# UNITED STATES PATENT AND TRADEMARK OFFICE

10/525,997

## **DETAILED ACTION**

FIG. 3.

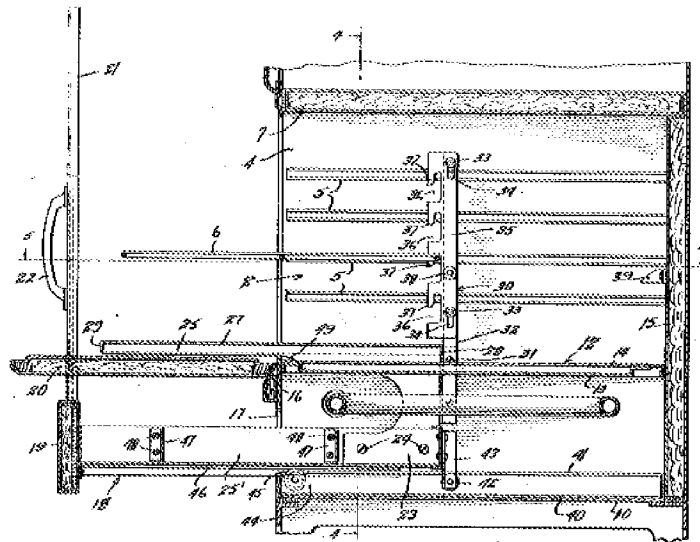
Regarding claims 8, 9, 11-14 and 16-21, US 2130167 (Weiskittel) shows (figure 3) and discloses a baking oven having:

- a baking chamber (2, 17);
- a baking rack (6);
- a holding part (27, 35) horizontally guided in said baking chamber and receiving and holding the baking rack, the holding part and said baking rack displaceable between a baking position with said baking rack inside said baking chamber and a removed position with said baking rack located, at least in part, outside and in front of said baking chamber; and

- two hooked rail retaining elements (23, 35), coupled to one another by a cross bracing (27), and arranged on opposite side walls of said baking chamber and at a distance from at least one of the top wall and the bottom wall of said baking chamber;

- each of the two retaining elements (35) is guided by a displaceable carriage (23, 42, 43) mounted on a guide rail (41) with rollers;
- wherein the guide rails are affixed to opposite side walls (3, 8), via a bottom wall (10), of the baking chamber.

Regarding **claims 13 and 20**, it is noted that the displaceable carriages (23, 35, 43, etc.) of **US 2130167 (Weiskittel)** move along with the baking rack (6) as it is oriented in the removed position, where the baking rack positioned, at least in part, outside and in front of said baking chamber (see figure 3). Therefore, the position(s) where the displaceable carriages (23, 35, 43, etc.) of **US 2130167 (Weiskittel)** reside when the baking rack (6) is located at the removed position (i.e. – “baking rack located, at least in part, outside and in front of said baking chamber”) is/are the same as applicant’s broadly claimed displaceable carriage “locating position”.

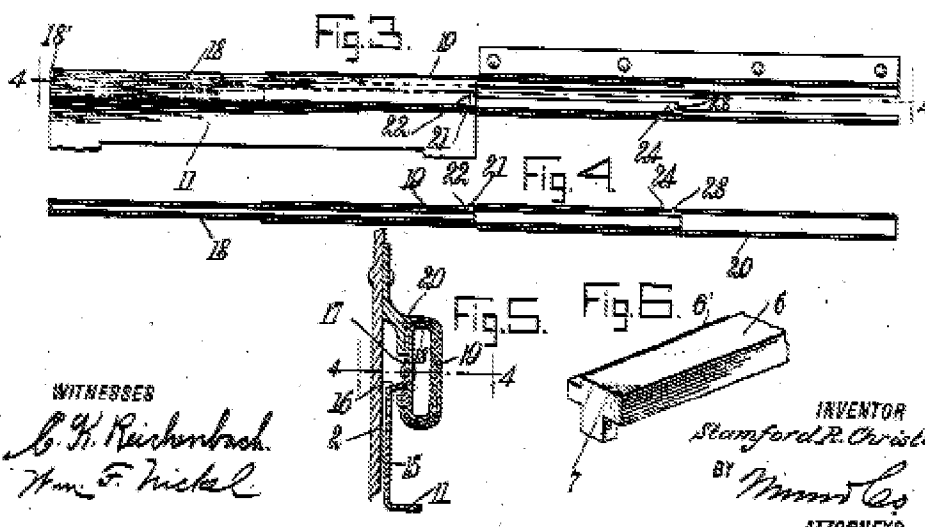
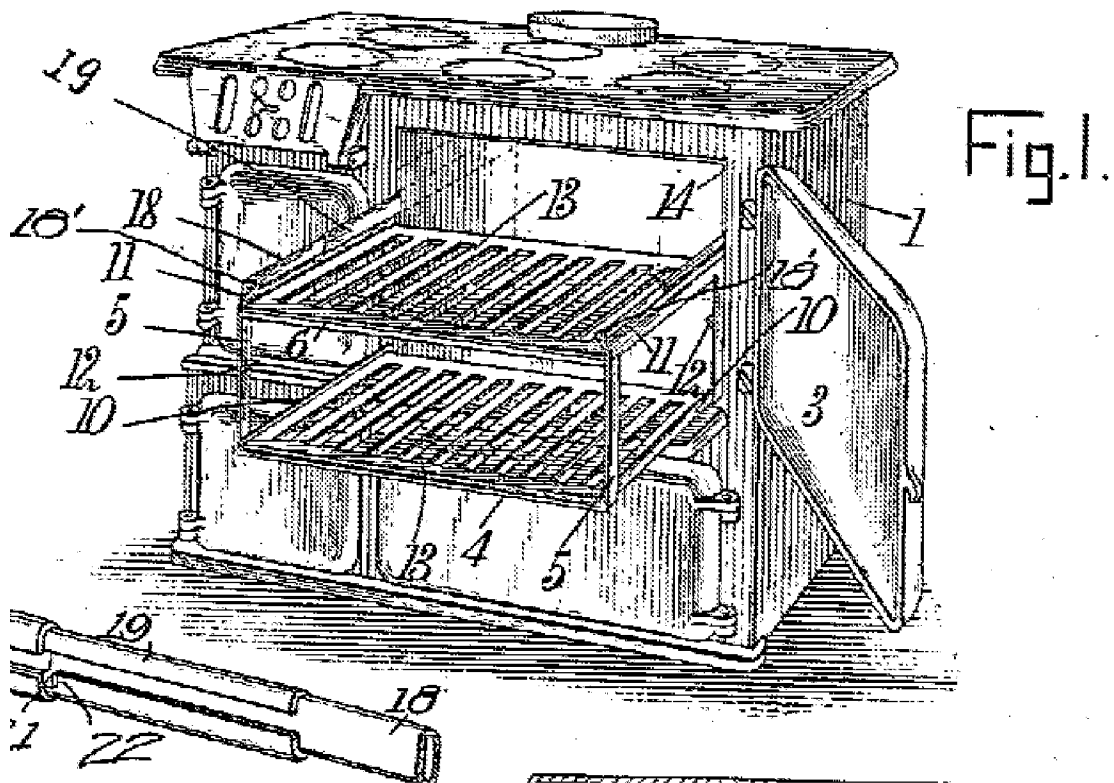
**Claims 8-11, 13, 16, 17, 20 and 26** are rejected under 35 U.S.C. 102(b) as being anticipated by **US 1063183 (Christian)**.

Regarding claims 8-11, 13, 16, 17, 20, and 26, US 1063183 (Christian) shows (figure 3) and discloses a baking oven having:

- a baking chamber (2);
- a baking rack (4, 6) insertable in said baking chamber;
- a holding part receiving and holding said baking rack and horizontally guided in said baking chamber;-

- wherein the holding part and said baking rack are displaceable between a baking position with said baking rack inside said baking chamber and a removed position with said baking rack located, at least in part, outside and in front of said baking chamber; and

- the holding part including two retaining elements (see figure 5; element 15, 16, 17) arranged on opposite side walls of said baking chamber and at a distance from at least one of the top wall and the bottom wall of said baking chamber;

- wherein each of the two retaining elements is guided by a displaceable carriage (18, 19);
- wherein each displaceable carriage includes a hooked rail (11) and which is affixed to on one of said opposite side walls of said baking chamber in a middle height region of said baking chamber;
